Site Survey of Selected Items
for
Compliance with the Americans with Disabilities Act
(ADAAG)
and
Title 24 of the CBC

The site survey of Woodrow Wilson High School was conducted on
February 27, 2007 during a spot check for compliance with the
Americans with Disabilities Act Guidelines (ADAAG)
and
Title 24 of the CBC

Facility Name: Woodrow Wilson High School

Boys Restroom next to the Small Gym

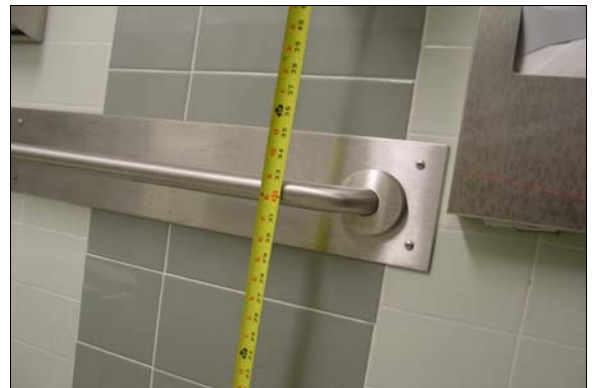
Finding: The door to the accessible toilet compartment does not close automatically or have accessible hardware.

Full Rec Provide an automatic door closer, spring hinge, pull bar or accessible handle mounted on the inside of the door. Accessible hardware on the inside and outside of the accessible toilet compartment shall be equipped with a loop or U-shaped handle mounted immediately below the latch. The latch shall be flip-over style, sliding or other hardware not requiring grasping or twisting.

Gymnasium in Building 100

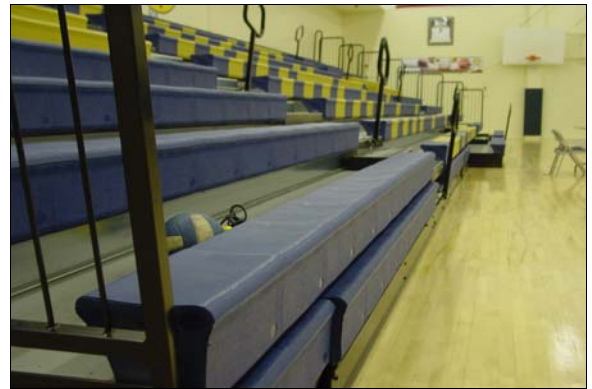
Finding: There are new pullout bleachers provide on both side of the gymnasium. The approximate spectator seating capacity in the gymnasium is greater than 800. At the time of inspection there were no designated wheelchair seating spaces that were identified by the international symbol of accessibility.

Full Rec Provide the compliant number of accessible wheelchair seating locations with at least one fixed companion seat provided next to each accessible wheelchair seating area (see ADAAG 4.33.3 and ADAAG Figure 46). Both the home and visitors side bleachers should have several accessible wheelchair locations with companion seating that provides a line of sight comparable to those of the general public in the gymnasium. Where total seating capacity exceeds 300, accessible wheelchair seating spaces shall be provided in more than one location (see CBC 1104B.3.5 and ADAAG 4.33.3.) Accessible seating areas must be identified with the ISA Symbol.
